## Determination 2008/116

### Refusal of a code compliance certificate for a new kindergarten at 74 Bowmont Street, Invercargill

Figure 1: Revised floor plan showing the gate and doors D01 and D02

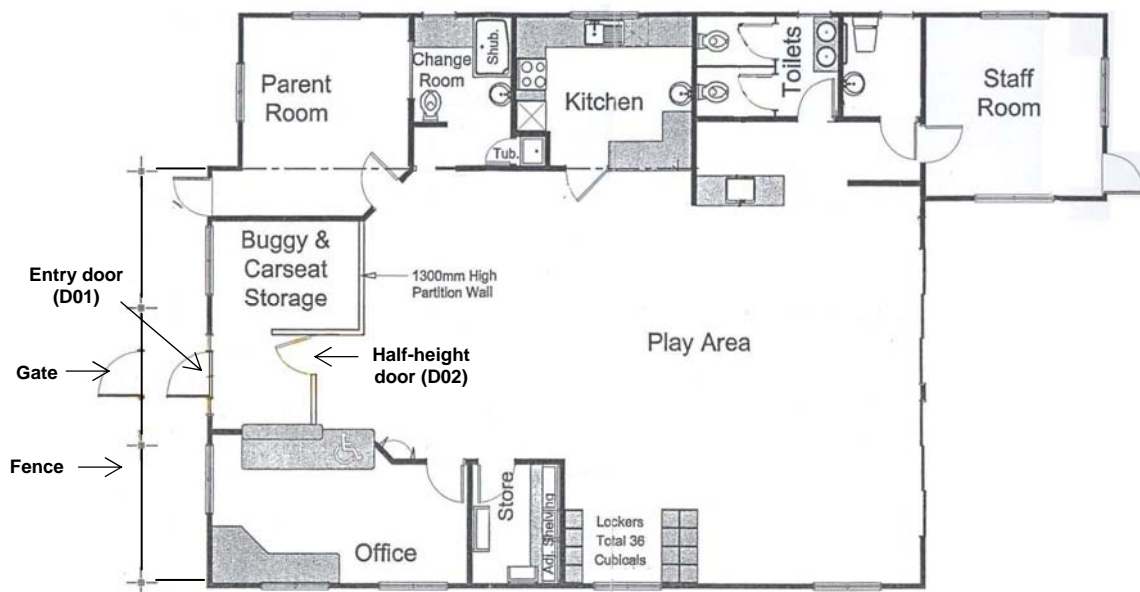
- 2.1 The building is a newly constructed kindergarten as shown in Figure 1 above. The main entry points to the building are located at the:
- 870mm wide x 1200mm high gate in the fence around the entrance area ("the gate"), which is hung on spring hinges and has a magnetically operated

latch with a “lift up” handle. The lift up handle can be operated by one hand and is currently set at a height of 1230mm above ground level.

- main entry door to the building proper (“door D01”) with a lever handle set at a height of 900mm above floor level. This door is not subject to this determination.
- internal half-height door, 1300mm high (“door D02”) that is situated between the entry foyer and the play area. It is controlled by a closing hinge and currently has a lever handle set at a height of 910mm above floor level and a supplementary magnetic bolt fixed near the top of its entrance side face. Entry through the half-door requires the use of two hands to operate the lever handle and latch simultaneously. The configuration of lever handle and latch requires someone to reach over the half-door to release it when leaving.

- Neither the height of the latch on the gate nor the two-hand operation necessary to open door D02 complied with the Building Code.
- Both NZS 4121 and D1/AS1 required "unaided" access and the authority would have difficulty accepting that the people in wheelchairs would require assistance to access the building.
- One possible solution could see the doors fitted with remotely-controlled locks with all users needing to use a buzzer to notify staff they need to be let into the building. Ease of access for those in wheelchairs would be the same as able-bodied users.
- The authority would consider the proposals discussed at the meeting as an alternative solution.

- the latch at the front gate is at a height which prevents operation by a person using a wheelchair to access the building via the principal access
  - the access through the internal half-door D02 requires two-handed operation which restricts use by a person using a wheelchair or other persons with disabilities who are unable to operate a two-handed latch.

- The removal of the existing lever handle on door D02 would mean that a person using a wheelchair could access the building through the principal access unaided. However, a person using a wheelchair would need to request adult assistance in order to leave the premises through the door. If this proposed solution was replicated on the gate, i.e. the existing latch was removed and replaced with a magnetic latch at 900mm above the ground, both the door and gate would meet the requirements for single-handed operation.

- The proposed latch configuration as described above would require a person inside the door or gate to reach over some 300mm to open the door to gain access to the outside. This would ensure that children of an age who are attending the kindergarten could not leave the building unaided. However additional protection would be required at the gate to prevent children reaching through the rails and opening the latch. This could be provided by

fixing sheets of clear plastic (for example acrylic or polycarbonate) over the full area of the gate and the adjoining side panel.

- To assist the exit of people in wheelchairs, a notice inside the main door access should also be provided setting out the need to request assistance from any adult person present in the building. The sign should also describe the procedure required for able-bodied adults to open the access door and gate in order to leave the building in the case of an emergency. In addition, the applicant has stated that all staff members would be instructed to provide such assistance.
